Drain: SPRINGMILL STREAMS DRAIN Drain #: 189
Improvement/Arm: SPRINGMILL RIDGE - SECTION 4
Operator: JDH Date: 7-15-04
Drain Classification: Urban/Rural Year Installed: 1987

GIS Drain Input Checklist

RE: Springmill Streams Drain-Springmill Ridge, Section 4 Arm

Attached is a petition, non-enforcement request, plans, calculations, Quantity Summary and assessment roll for the Springmill Streams Drain, Springmill Ridge, Section 4 Arm.

TECH. CHK.	DRAWN BY	SCALE	DATE	CLIENT	DWG. TYPE	FILE NUMBER
DFTNG. CHK.	DRAWING TITLE	1" = 50'	1-14-06	SPRINGMILL RIDGE SECTION - FOUR		
						JOB NUMBER
						79205-30104
						2

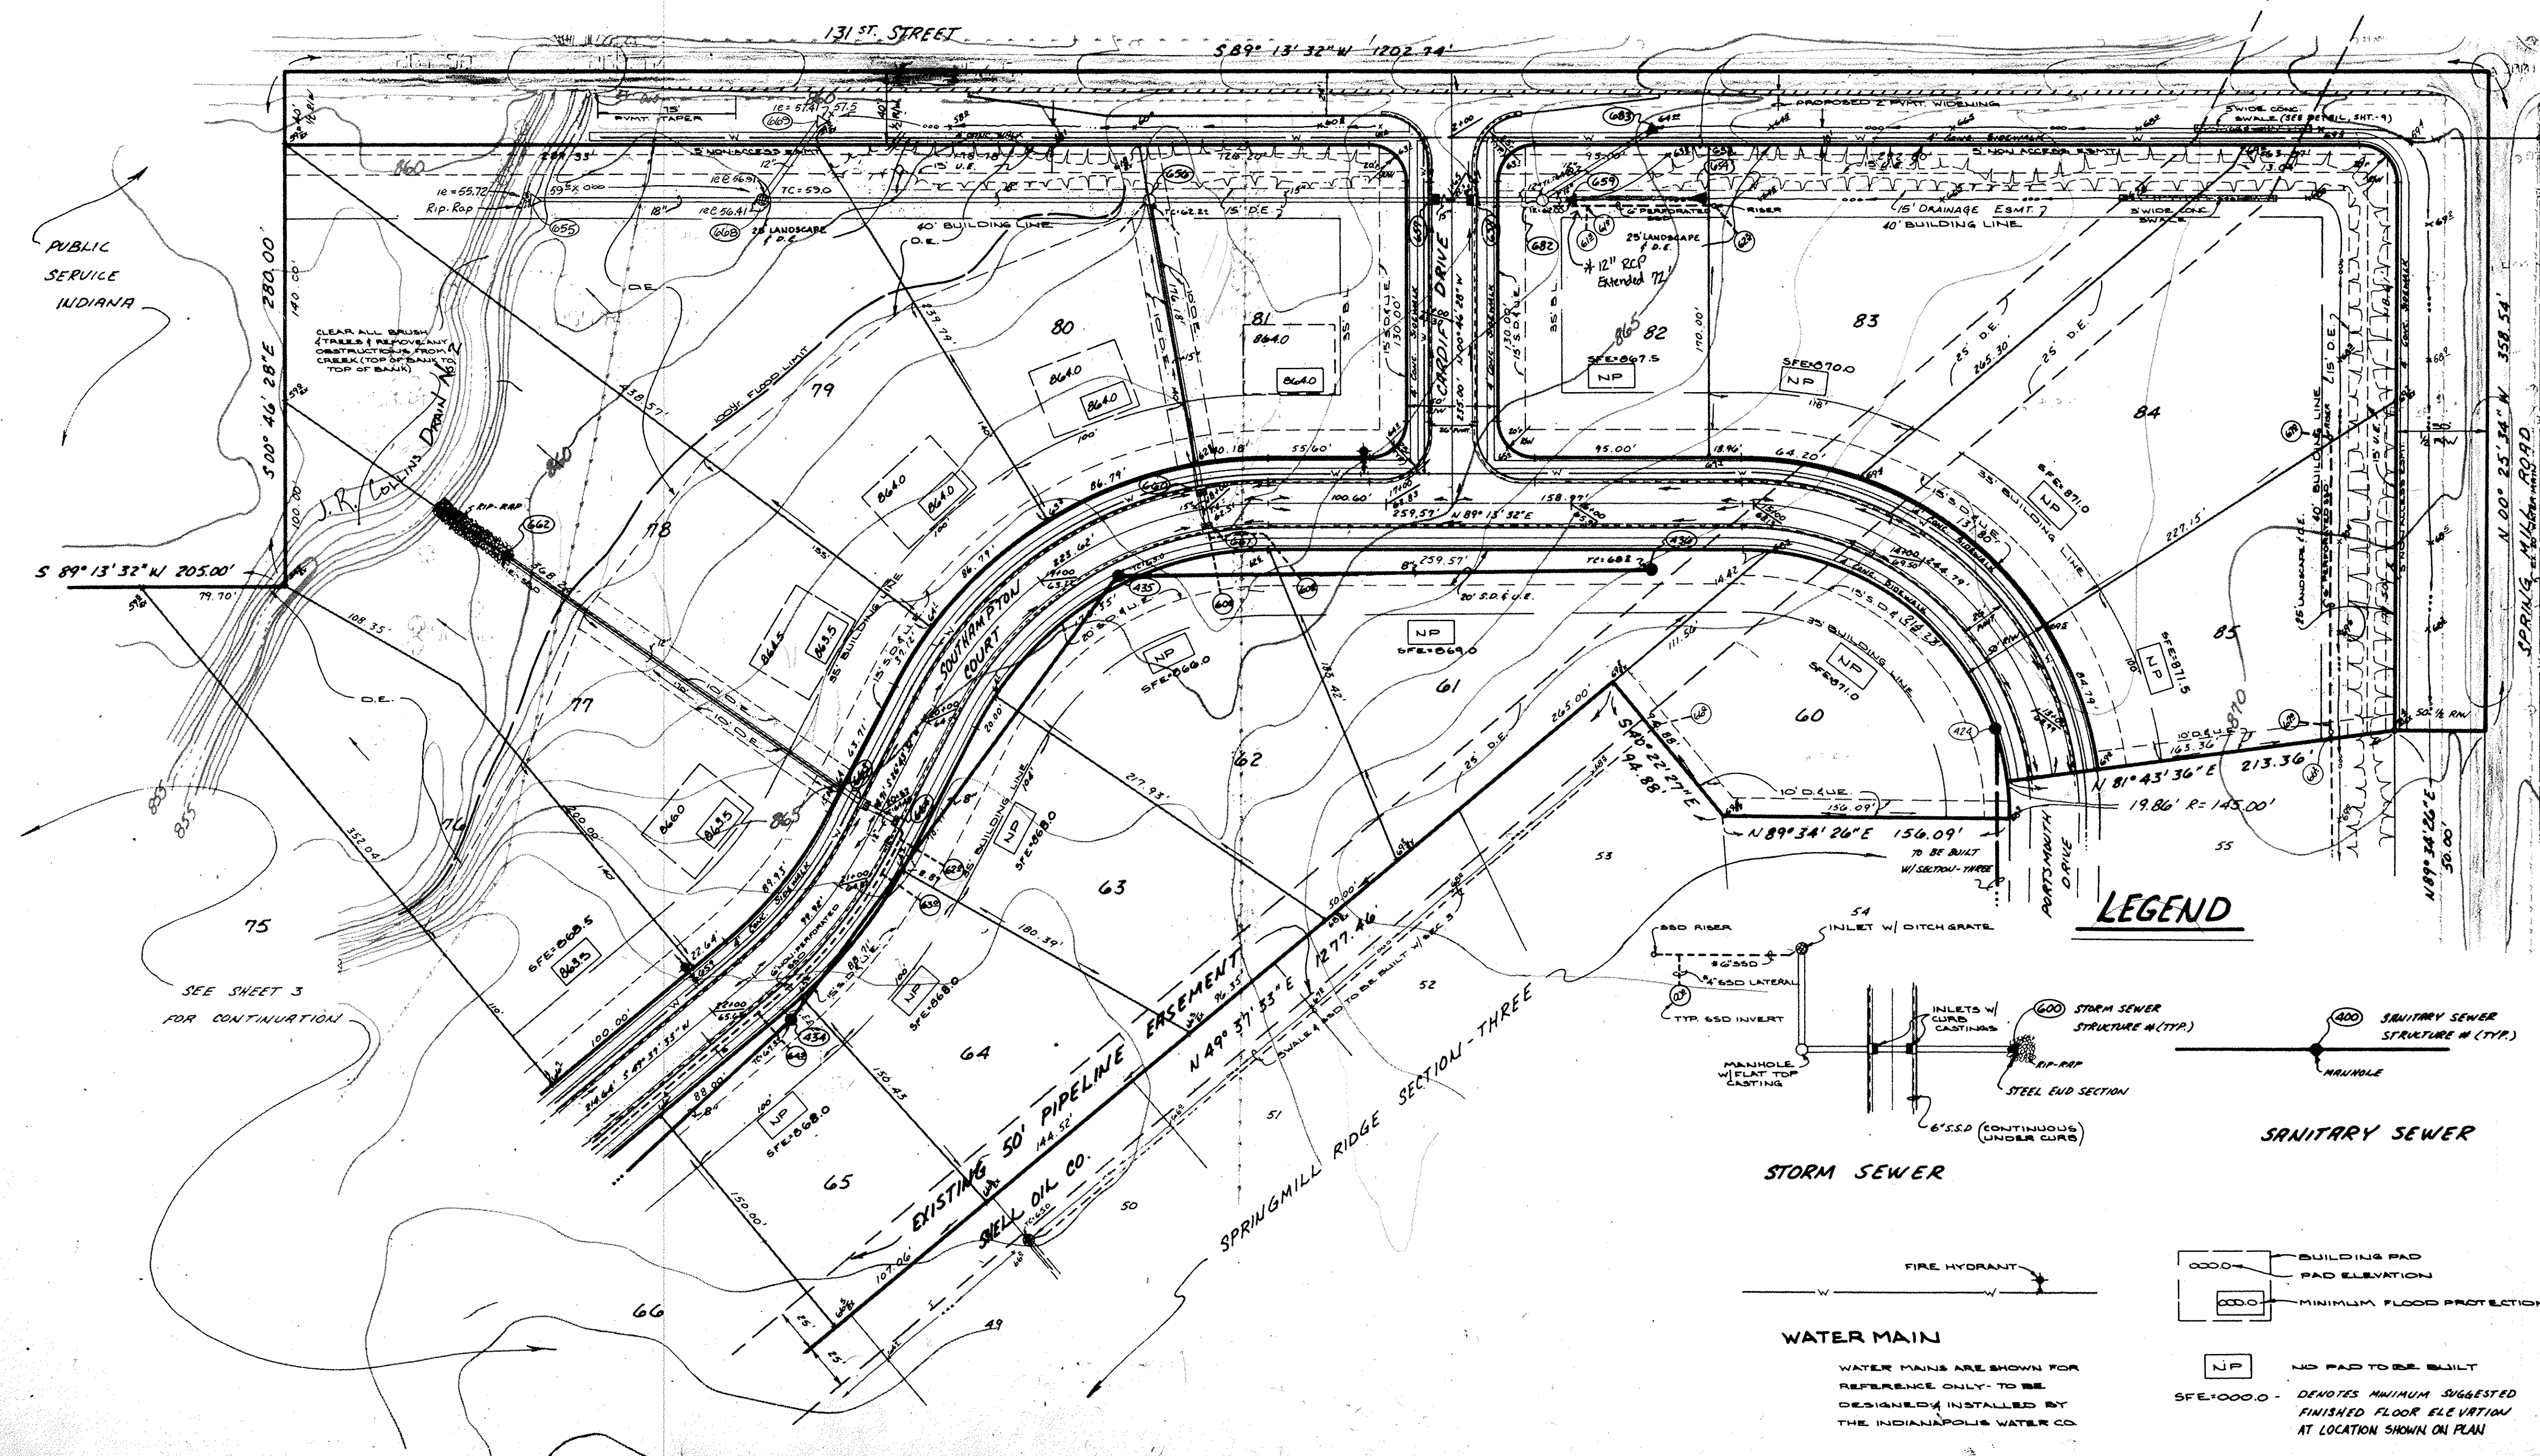
Only one minor change was made during the construction of the drainage facilities. Instead of outletting the subsurface drain along 131st Street into STR 658 it was instead placed in STR 682. The length of the drain remains the same as stated in my September 13, 1987 report at 2074 feet.
